## ITEM 1 -- PUBLIC WORKSHOP ON DRAFT ORDER REQUIRING PG&E TO CLEANUP AND ABATE ITS DISCHARGES OF CHROMIUM TO GROUNDWATER IN THE HINKLEY AREA

# Hinkley – Groundwater Remediation Program

### Prosecution Team Explanation of Consensus Changes CAO R6V-2015-DRAFT

## **Program-wide Monitoring Changes #2**

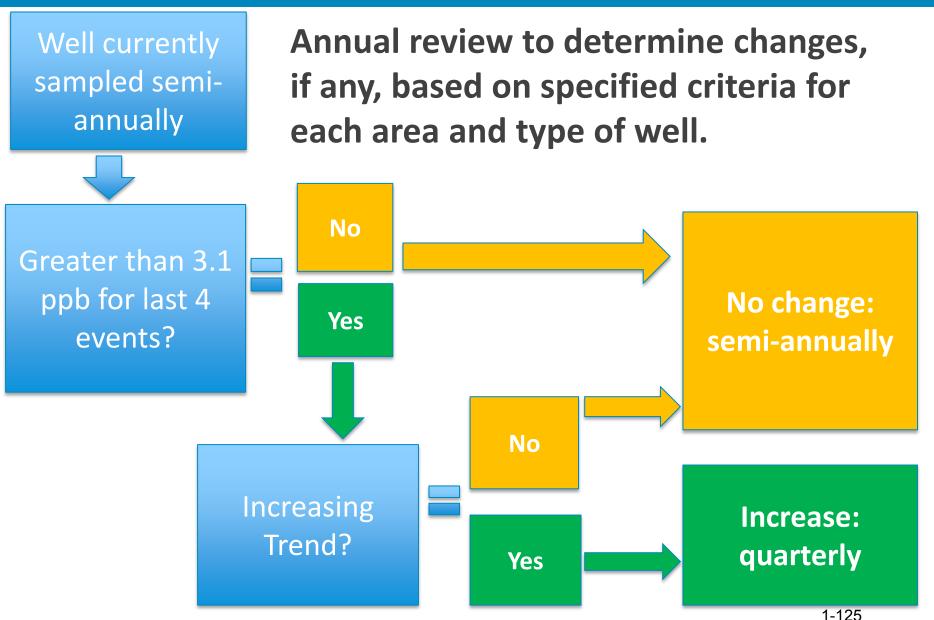
Annual review of sampling data will determine required sampling frequencies (quarterly, semi-annually, annually, every other year) at monitoring wells

Sampling frequency may increase or decrease based on the following criteria (no monitoring wells to be abandoned):

- Results over time consistently above or below:
  - Established background level (3.1 ppb)
  - MCL (10 ppb)
- Mann-Kendall trend analysis (Trending up, down, or no trend)
